Project	IEEE 802.16 Broadband Wireless Access Working Group < http://ieee802.org/16 >	
Title	Text remedies for credit token based co-existence protocol section	
Date Submitted	2006-07-10	
Source(s)	David Grandblaise Motorola Labs Parc Les Algorithmes Commune de Saint Aubin 91193 Gif sur Yvette, France	Voice: +33 (0)1 6935 2582 Fax: +33 (0)1 6935 4801 mailto: david.grandblaise@motorola.com
Re:	Recirculation of Working Group Review of Working Document 80216h-06_015	
Abstract	This contribution provides remedies to comment #3 of the session #43's Working Group Review. The text remedies for credit token based co-existence protocol are proposed for section 15.6.2.2.6 of the working document [1].	
Purpose	Text remedies to comment #3 of the session #43's Working Group Review.	
Notice	This document has been prepared to assist IEEE 802.16. It is offered as a basis for discussion and is not binding on the contributing individual(s) or organization(s). The material in this document is subject to change in form and content after further study. The contributor(s) reserve(s) the right to add, amend or withdraw material contained herein.

Text remedies for credit tokens based rental protocol secti

Figure h44: Example of TDD based MAC frame sharing structure between M $SYSsNWs$

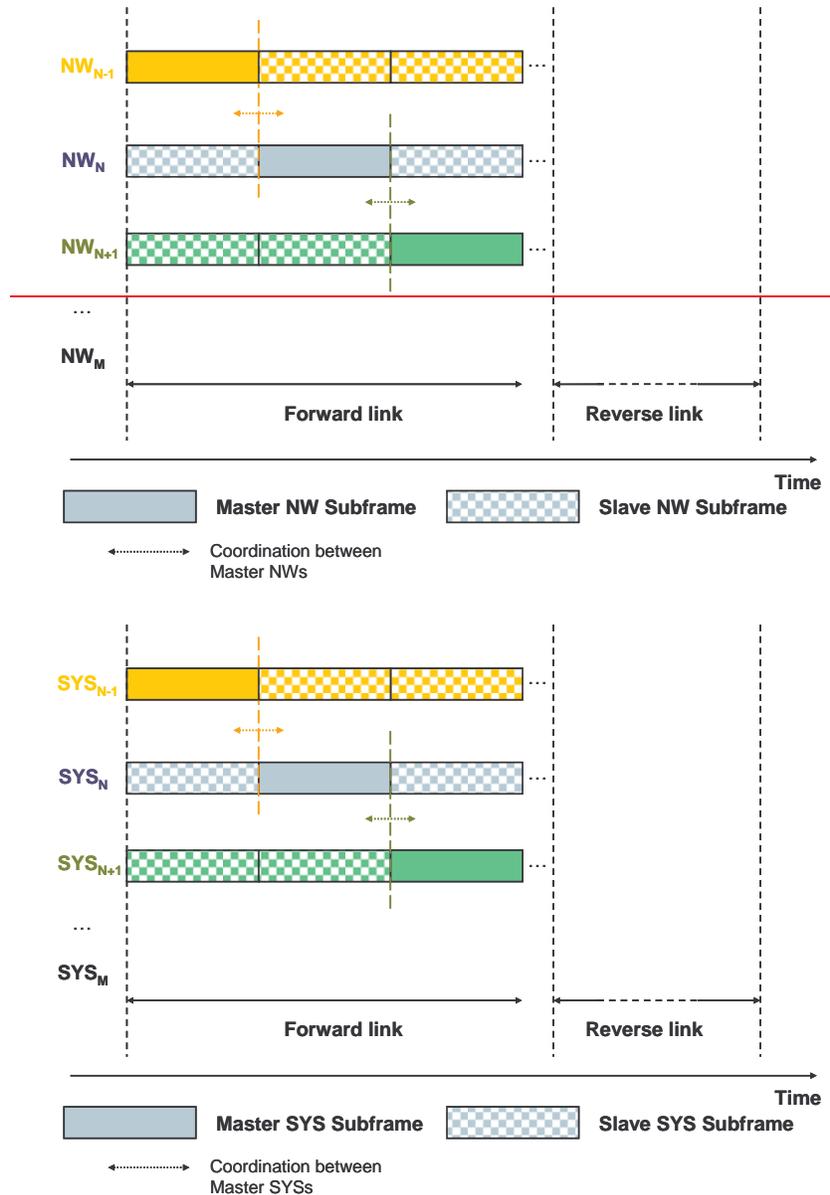
Spectrum sharing between several systems (SYS) ~~networks (NW)~~ can be achieved through the sharing of a common MAC frame between the different SYS~~NWs~~ as exemplified by Figure h44. In such a MAC frame structure, dedicated portions (denoted as “master SYS~~NW~~ sub-frames”) of the frame are periodically and exclusively allocated to a SYS~~NW~~ (denoted as the “master SYS~~NW~~”) respectively in the forward and reverse link. The terminology used hereafter defines a slave SYS~~NW~~ as a SYS~~NW~~ that may operate during the other master SYS ~~NWs~~ sub-frames. With respect to this definition, the slave SYS~~NW~~ sub-frames are the time intervals operating in parallel of the master SYS~~NWs~~ sub-frames.

Figure h47: Simplified MAC frame structure illustrating master SYS_{NW} sub-frame renting principle and associated notations

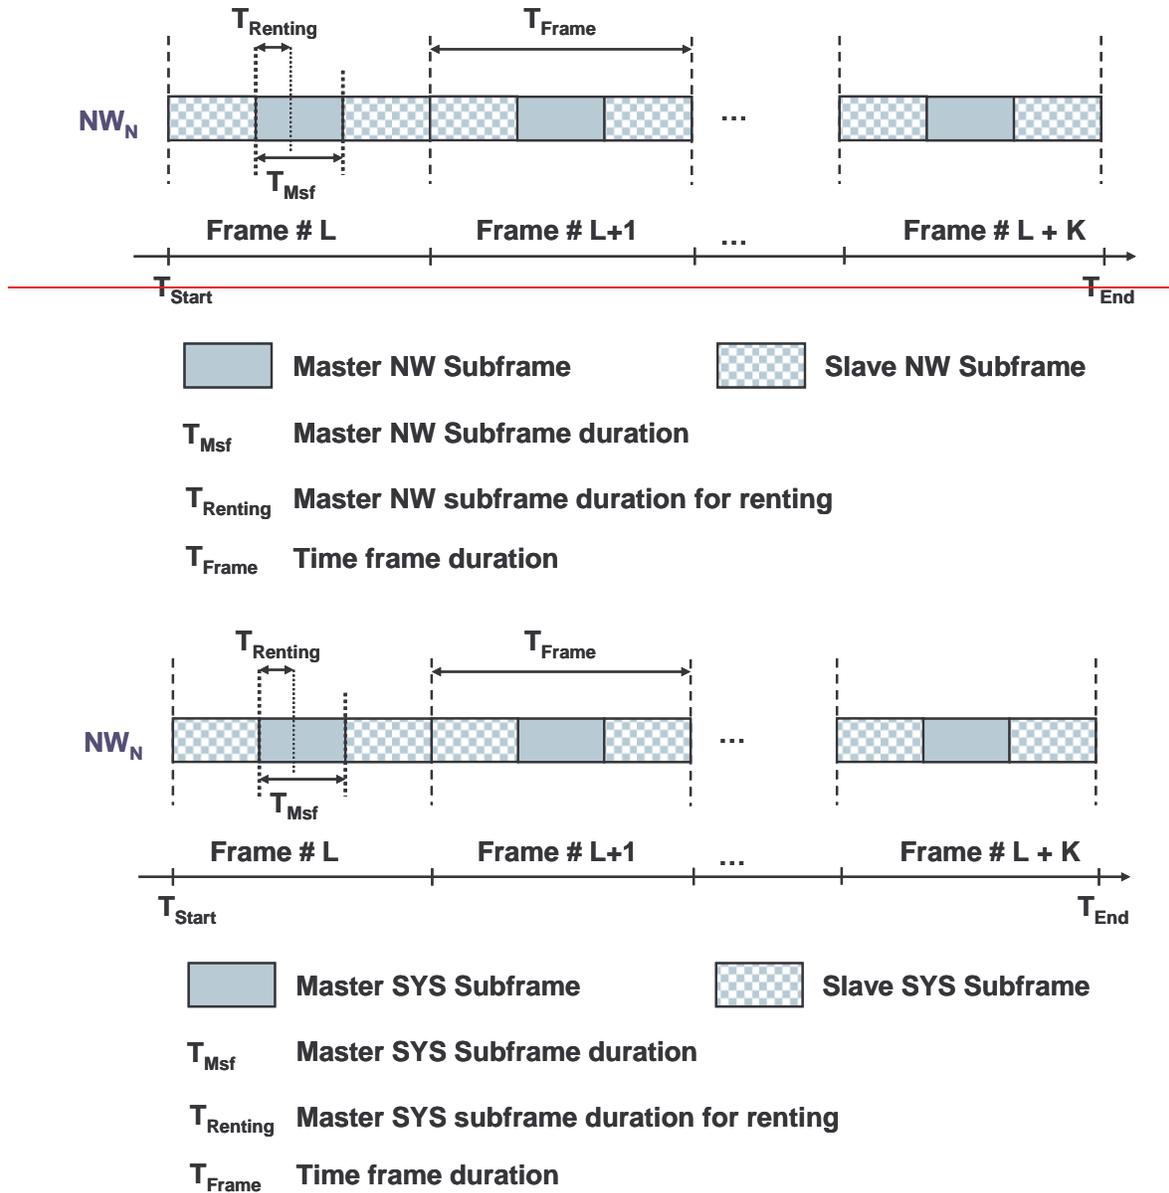
- The master NW_{SYS}_N (seller/offeror) advertises that its periodic assigned master sub-frame is open for renting (Figure h47) from starting time T_{Start} to ending time T_{End} for a fraction ($T_{Renting}/T_{Msf}$) of its master sub-frame duration T_{Msf} . $T_{Renting} = T_{End\ Renting} - T_{Start\ Renting}$.
- The master NW_{SYS}_N proposes a **reserve price auction RPA** minimum number of credit tokens required (**MRCTN**) for this renting. The **RPAMRCTN** is expressed as a number of credit tokens per time unit.
